**Subject:** Pressurized Water Reactor Owners Group  
**Responses to the NRC Request for Additional Information (RAI) on  
WCAP-16530, "Evaluation of Chemical Effects in Containment Sump  
Fluids to Support GSI-191"**

TAC No. MD1119

**Response to NRC Request for Additional Information on  
WCAP-16530-NP, Rev. 0, “Evaluation of Post-Accident  
Chemical Effects in Containment Sump Fluids to Support  
GSI-191”**

Revised Figure 5.2-16: Volume of Precipitate Observed in the Settling Cones

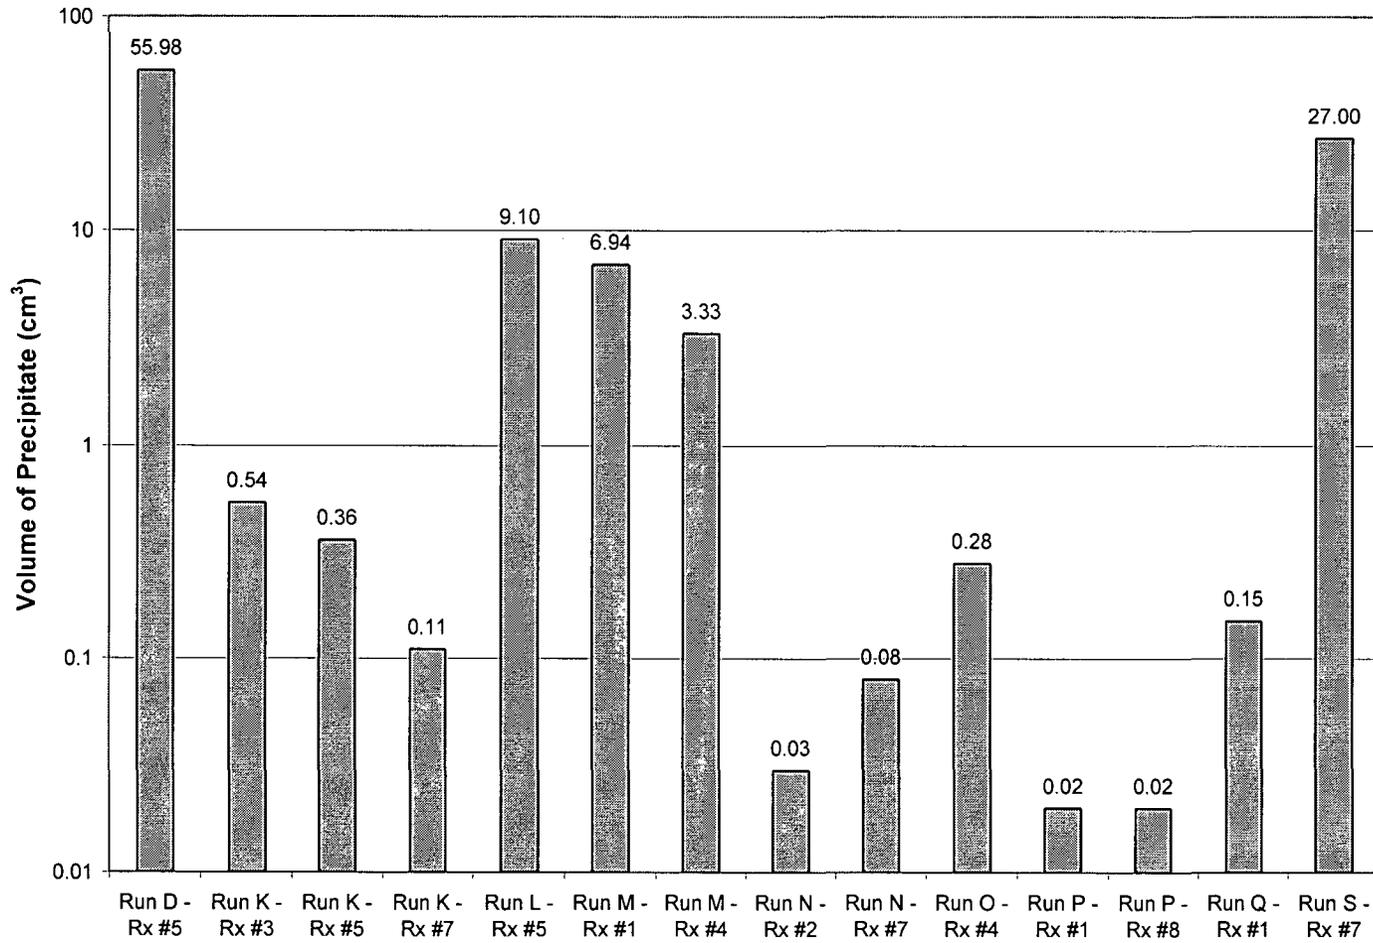
Discussion of precipitate formation on Page 78 states that measurable quantities of precipitates were formed in 25 experiments and the volume of precipitate formed for these cases is shown in Figure 5.2-16. This figure identifies the volume of precipitate observed for 14 run/reaction vessel designations. Later in the discussion, the TR indicates that Table 5.2-4 lists the experiments (13 of 60 experiments) where measurable precipitation occurred. Some of the run/reactor identities in Figure 5.2-16 (e.g., P1, P8, Q1) do not match with the identities in Table 5.2-4 (e.g., K2, K4, N2). Please clarify the discrepancy in the

number of experiments with measurable precipitation and test run identifications between Table 5.2-4 and Figure 5.2-16. For all experiments with measurable precipitate, please provide a table showing:

The discussion refers to 25 experiments in which precipitates formed which is a larger number than in Figure 5.2-16 or Table 5.2-4. The 25 value included runs that were rejected for experimental difficulties. The correct value is 17.

A corrected Figure 5.2-16 is shown below. The original figure included Run M7, a bad run, which has been eliminated. Run N2 was mislabeled as N5, which has also been corrected. The original figure also included only precipitates that formed by cooling from 265 °F. Four runs have been added (D5, P1, P8, and Q1) where precipitates formed upon cooling from 190 °F, even though these runs were not included in the precipitation test matrix. This figure does not include the 3 precipitates that formed by mixing different solutions, since different volumes of solution were involved than for the cooling tests.
